Environmental
Protection
Authority

Pluto Liquefied Natural Gas Development (Site B Option) Burrup
Peninsula, Shire of Roebourne – inquiry under section 46 of the
Environmental Protection Act 1986 to amend Ministerial Statement 757

Report 1734
March 2023

Inquiry under section 46 of the *Environmental Protection Act 1986*

Figure 1: Pluto LNG Facility Train 1 – Interim targets (Woodside 2021c)

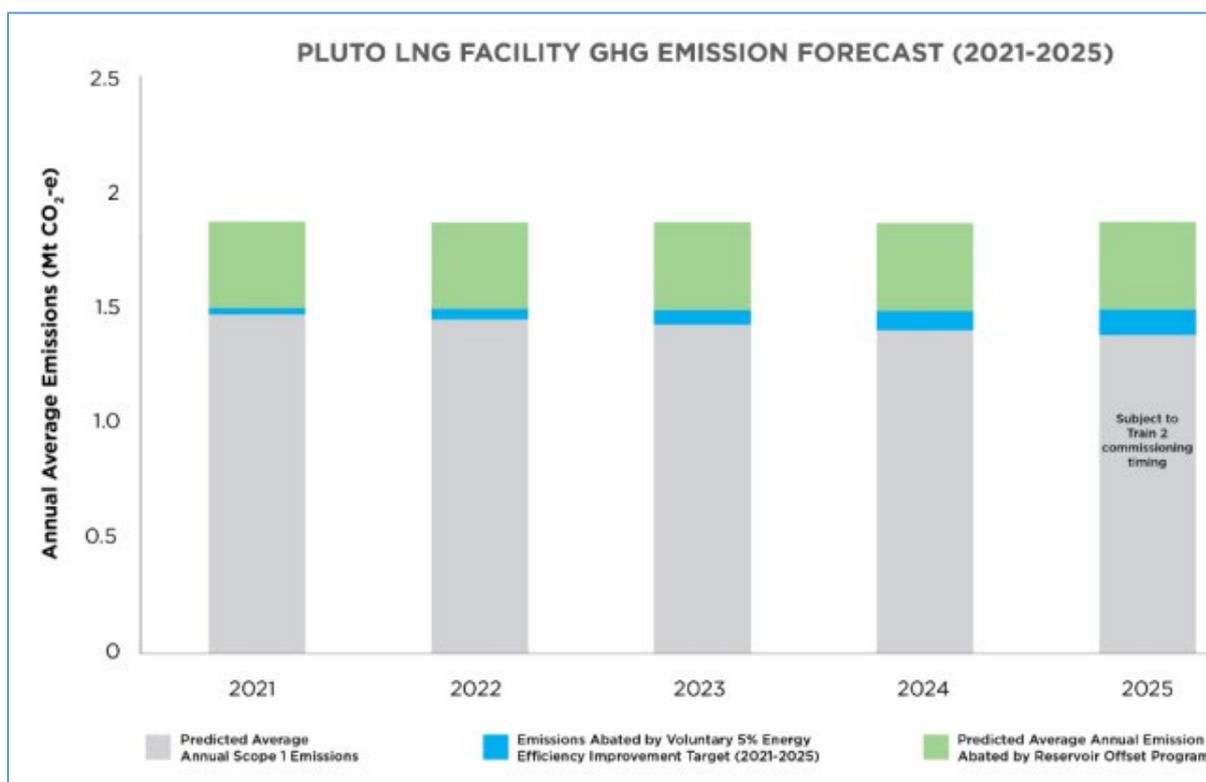
The Pluto GGAP (Woodside 2021c) presents the interim emissions reduction targets for 2021 to 2025 in Figure 1 (below) showing:

- the average predicted scope 1 GHG emissions from Pluto LNG Train 1 is 1.92 Mtpa of CO₂-e
- the average predicted reservoir emissions
- the emissions abated through the proponent's 5% energy efficiency improvement target (2021-2025) (Woodside 2021c).

The Pluto GGAP (Woodside 2021c) details that the 5% energy efficiency improvement target is 'determined as a 5% improvement in the average GHG intensity from the previous 5-year period (that is 2016–2020) using NGERs methodology outlined in Appendix C' of the Pluto GGAP. The Pluto GGAP also details that this is 'dependent on production volume and gas composition' (Woodside 2021c).

Figure 2: Pluto LNG Facility Trains 1 and 2 – Interim and long-term targets (Woodside 2021c)

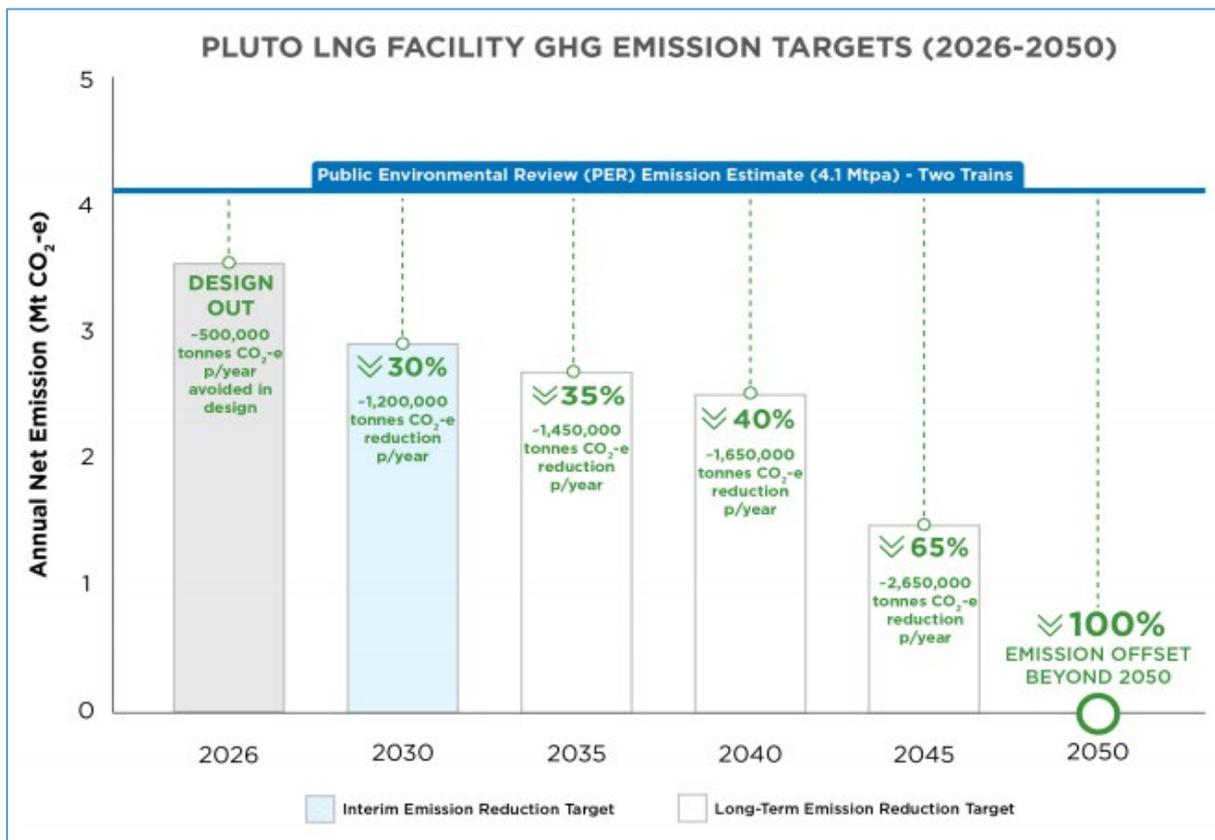
The interim emissions reduction targets from 2026 to 2034 are shown in Figure 2.

The long-term emissions reduction targets are shown in Figure 2 and are detailed below:

- 'Reduce or abate emissions by 35% by 2035
- Reduce or abate emissions by 40% by 2040
- Reduce or abate emissions by 65% by 2045
- Reduce or abate emissions by 100% by 2050' (Woodside 2021c).
